# QUEENSTOWN LAKES DISTRICT COUNCIL

Hearing of Submissions on Proposed District Plan

Report and recommendations of Independent Commissioners  
regarding mapping of Wakatipu Basin and Arrowtown

Report 18.3 - Area A  
Western Basin

Figure 2: Blue hatched area showing recommended extent of Precinct and Landscape Feature line, as per Figure 3 of Ms Gilbert’s reply evidence

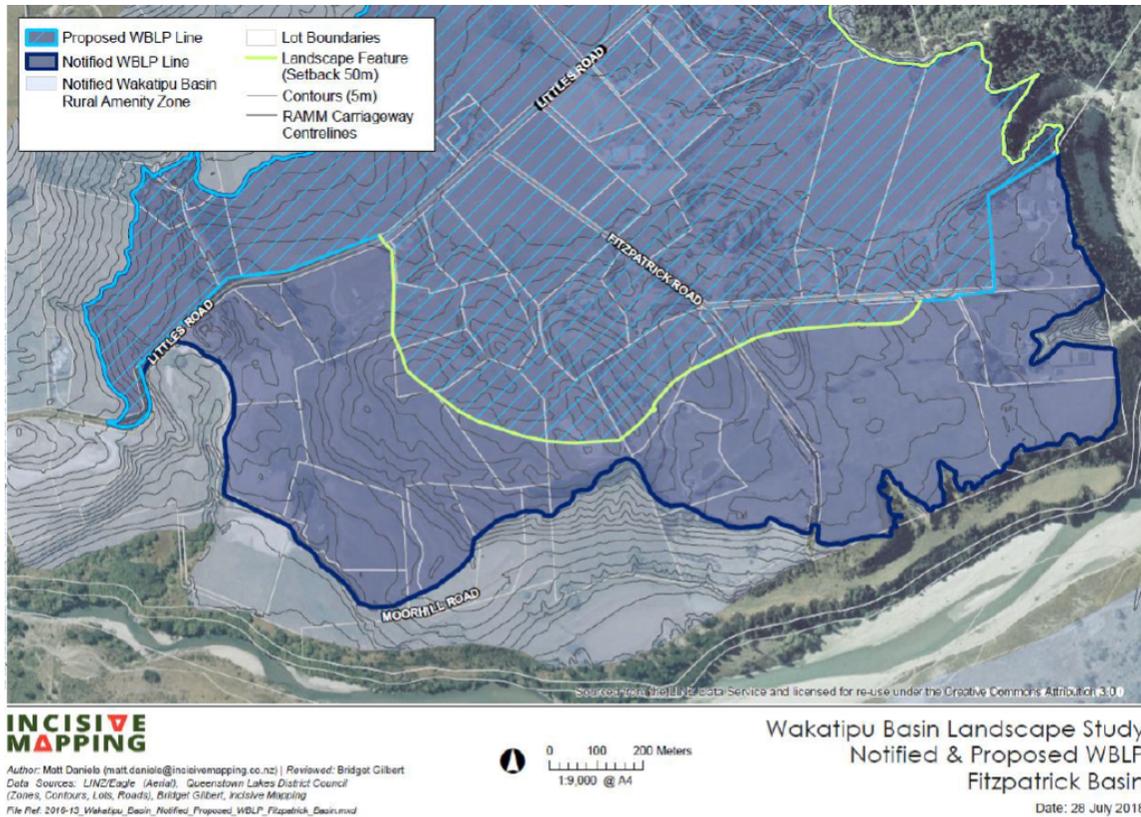
14. We discussed our impressions from our site visit with Ms Gilbert, which were that the southern edge of the Precinct zoned land 'rolled over' into the Shotover River terraces, rather than sloping inward to the basin. This had the effect of making this land more visible from the Shotover River and adjoining public land than the land within the Fitzpatrick Basin proper. Ms Gilbert addressed this issue in her reply evidence<sup>7</sup>. After reviewing the mapping analysis of the area and site photographs, she concluded the area in question did read as part of LCU 3 and demonstrated a similar sensitivity to landscape change and capability to absorb additional development as outlined in the Schedule 24.8 description for LCU 3. For those reasons, she recommended the alignment of the Precinct boundary and Landscape Feature line be amended as shown in Figure 2 below.

15. Mr Langman advised us there was scope to remedy this and the change would *‘better protect and maintain the landscape values of the area, including the interaction of the lower terrace and the Shotover River ONF/L.’*<sup>8</sup> We rely on this advice as to scope although we note that more general submissions seeking the deletion of the Precinct in total also provide scope<sup>9</sup>.

16. We agree with Ms Gilbert and Mr Langman. In our view, this amendment would better achieve the Strategic Direction of the PDP and the objectives of Chapter 24. Therefore we recommend the Precinct be reduced in area and the Rural Amenity Zone extended, and an Escarpment, Ridgeline and River Cliff Features line be applied in the locations shown on Figure 3.

Figure 3: Recommended Zoning in Vicinity of Fitzpatrick Basin

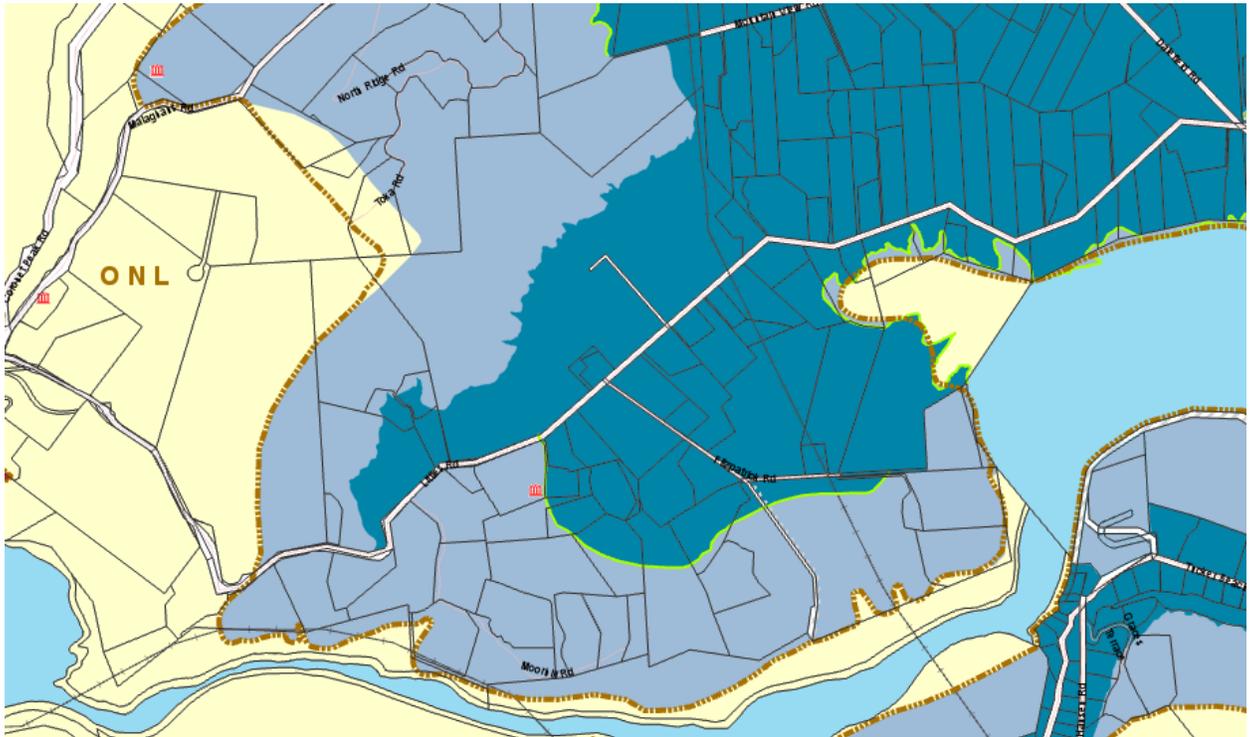
18. In conclusion, we recommend the area south of Littles Road and the Fitzpatrick Basin be zoned as shown on Figure 3 below:

- i. Further Submission 2714 by J Muspratt be accepted;
  - j. Further Submission 2802 by Tucker Beach Residents Association be accepted;
  - k. The Rural Amenity Zone be applied to part of the land to the south of Littles Road as shown in Figure 3 above.

- l. The Escarpment, Ridgeline and River Cliff Features Line be relocated in the area south of Littles Road as shown in Figure 3 above.
  - m. The boundary of LCU 2 and LCU 3 is amended as shown in Schedule 24.8 in Appendix 1 to Report 18.1.
